**CONSULTATION REPORT**

# **Report on the public consultation regarding the adequacy and flexibility study 2022-2032**

**FINAL VERSION**

**22/02/2021**

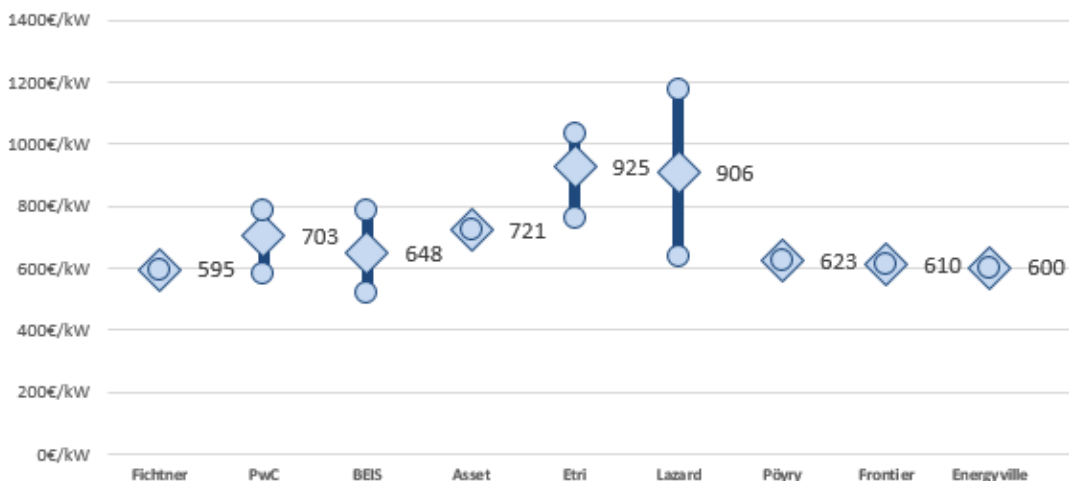
|  | <p>First, we understand that Elia refers here to the total capex (of which the EPC cost represents a significant part). Electrabel does not agree with the proposed total capex level as these do not take into account the recent technology developments (HL-class CCGT). The below analysis is an update of the Gas Turbine Handbook for the year 2020 for the EPC costs, which is – in our opinion – the latest public information on the topic. However, it is important to mention that this source does not yet consider the next generation HL-class CCGT plants that are in development phase and will be the reference for the coming years, for which even lower EUR/kW costs can be achieved due to their greater scale and efficiency. Electrabel refers here to an example of the next-generation HL-class CCGT plant recently announced by Edison in Presenzano, Italy, while the investment required for this plant is significant, amounting to EUR 370 million (EPC cost only).</p> <p>Therefore, taking into account these important evolutions, we recommend Elia to use, at the minimum, the GTH updated values for 2020 and integrate an error margin of minimum -15% to the reference data to capture the evolutions in the market.</p> <p><u>New capacity – OCGT:</u></p> <p>The broad range of OCGTs makes it very complex to provide average capex levels. In the case of OCGTs, the scale effect also plays an important role.</p> |

ELIA thanks FEBEG and ENGIE Electrabel for their comments on the proposed CAPEX for CCGT units.

Following feedback received during the previous year, ELIA has already decreased the CAPEX for large CCGTs from 750 eur/kW to 600 eur/kW by splitting the CAPEX for different size categories. It results that large CCGTs, given technology evolutions and costs, tend to have lower costs per kW than smaller scale ones. The CAPEX estimates are to be understood as including all costs that need to be spent to build a certain unit and not only the EPC ones. In addition, ELIA has looked into several sources to provide those estimates (including a recent report by EnergyVille<sup>18</sup> that ENGIE commissioned where 600 eur/kW was used for new CCGTs). It results that for the CCGT, 600 EUR/kW seems to be a value that is in –line with (or sometimes even below) the different studies and sources found.
